PROJECT REFERENCE NO.	SHEET NO.
R-3100B	EC-20/CONST.06
RW SHEET NO.	
ROADWAY DESIGN ENGINEER	HYDRAULICS ENGINEER

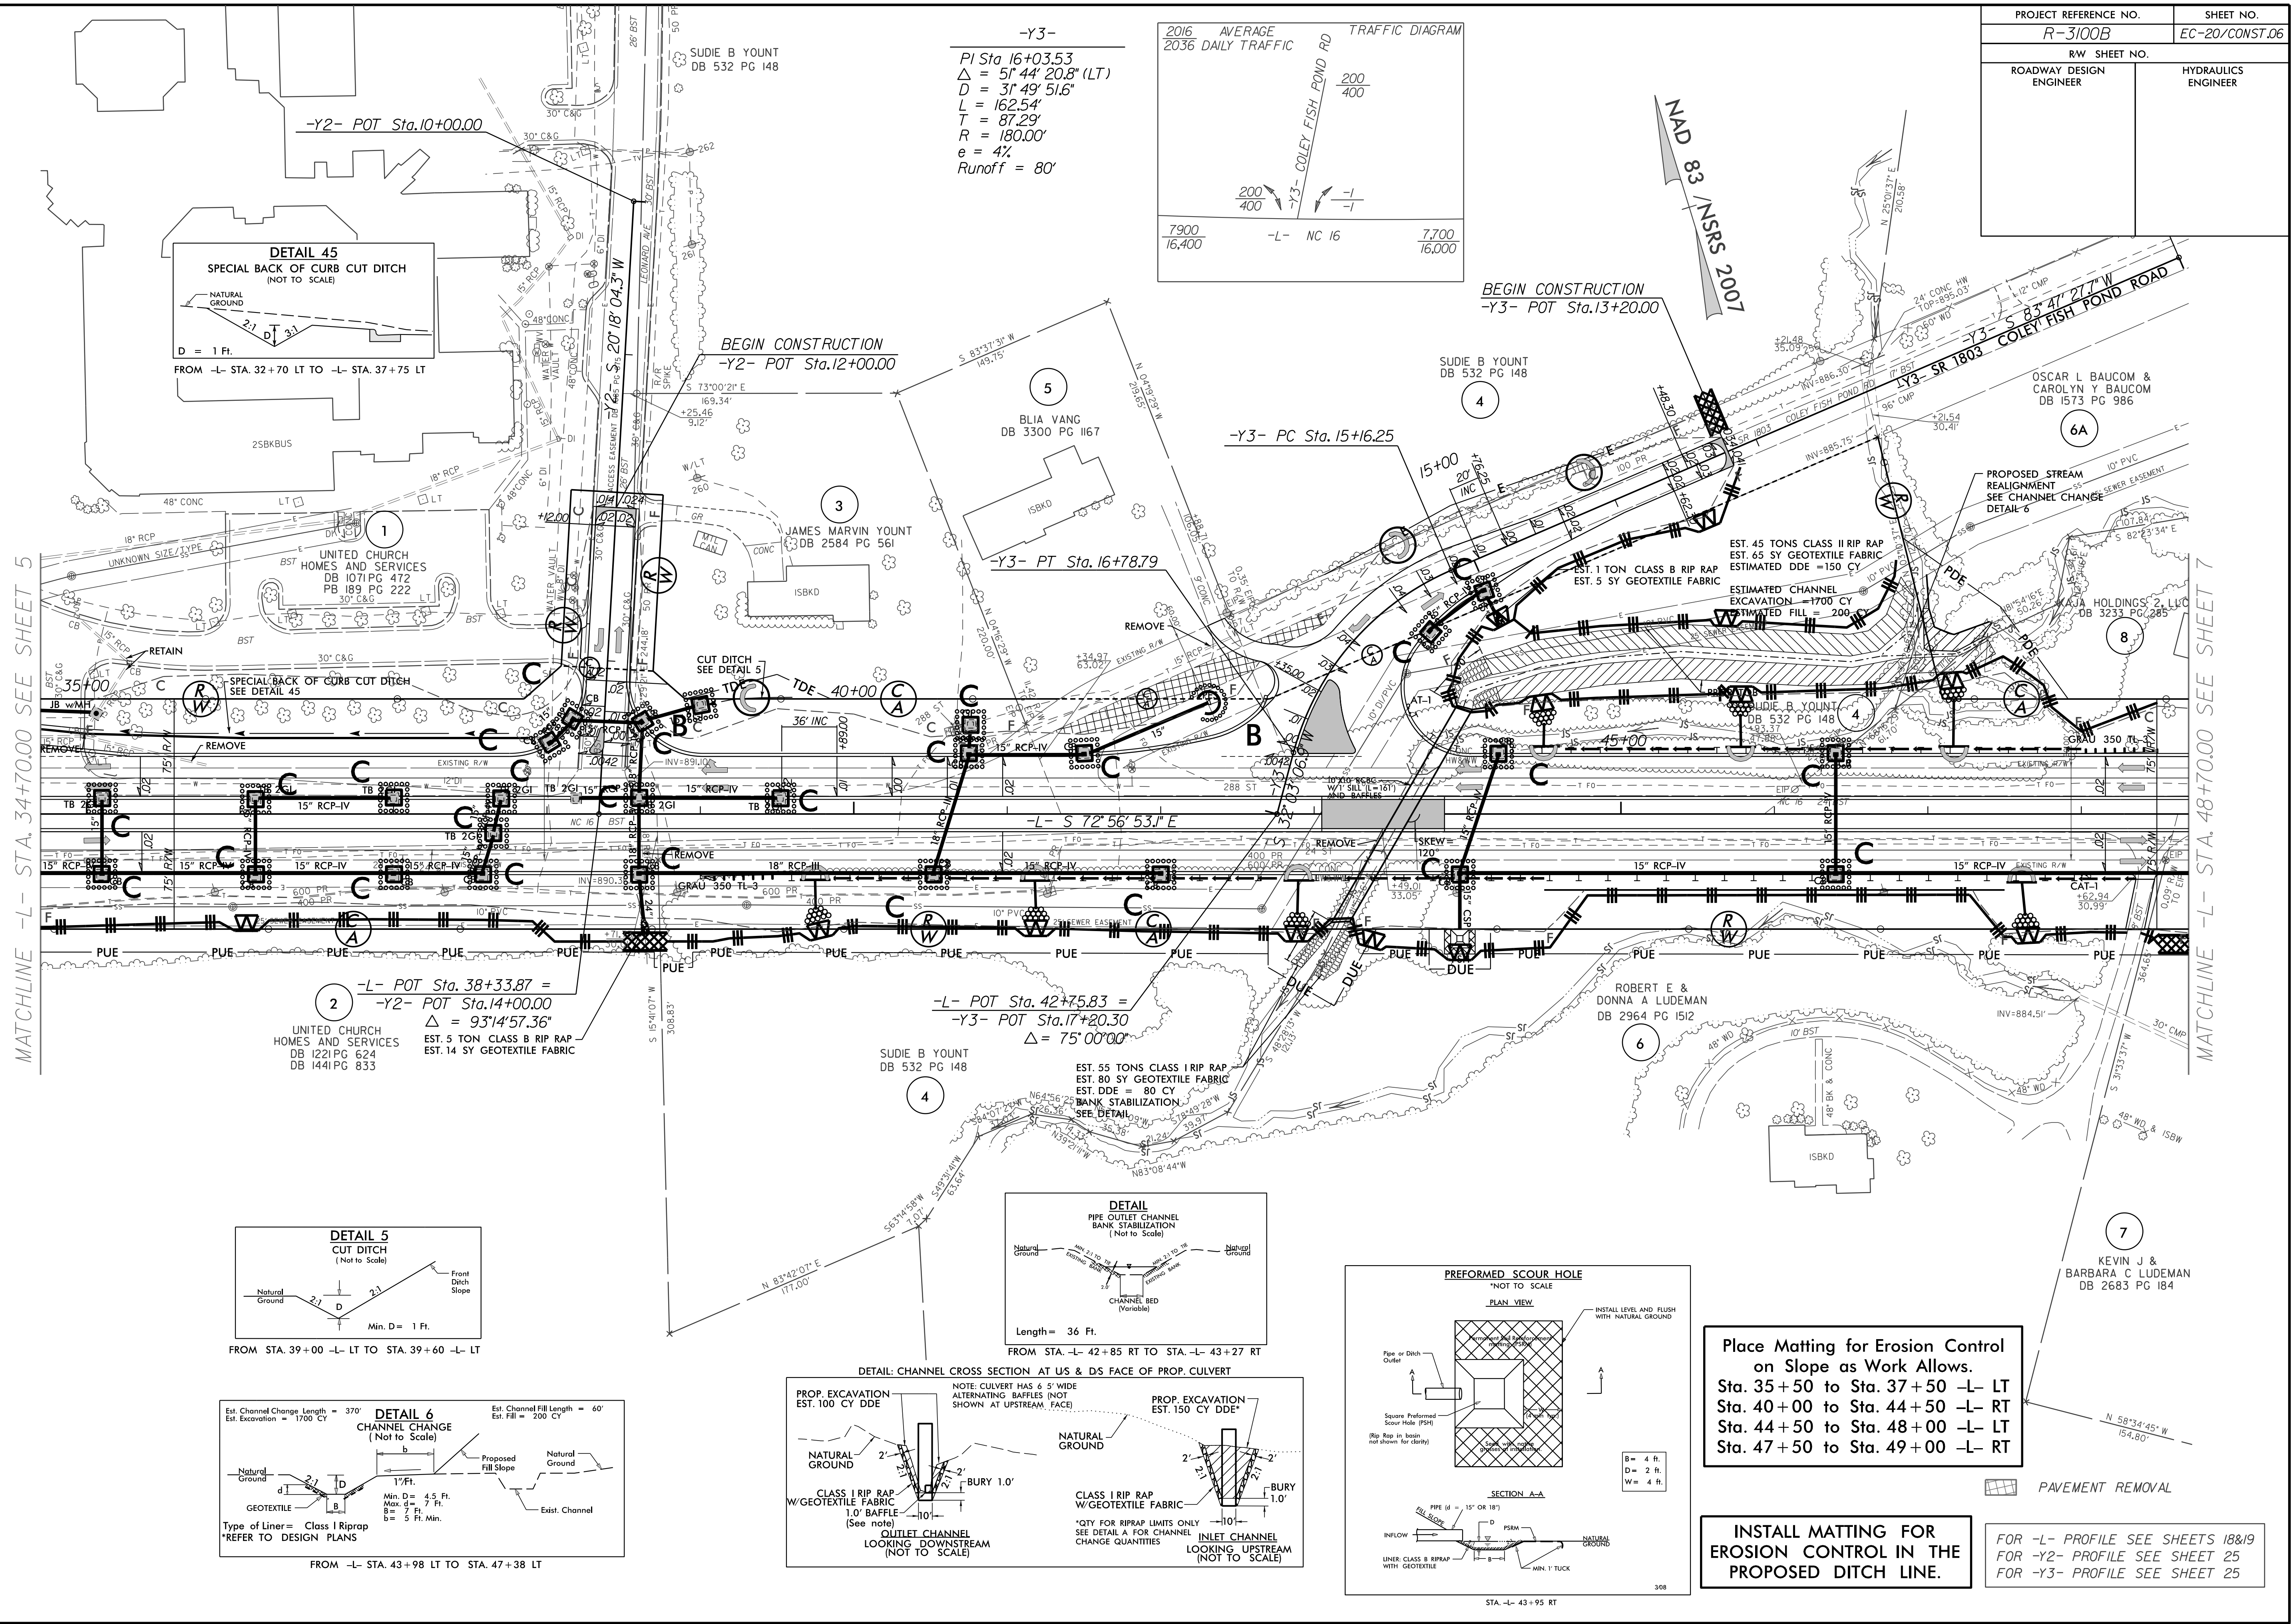
DATE: 06/09/2016 - REMOVED EXTRACT ON PARCEL 1 STA. 35+50 TO STA. 36+40
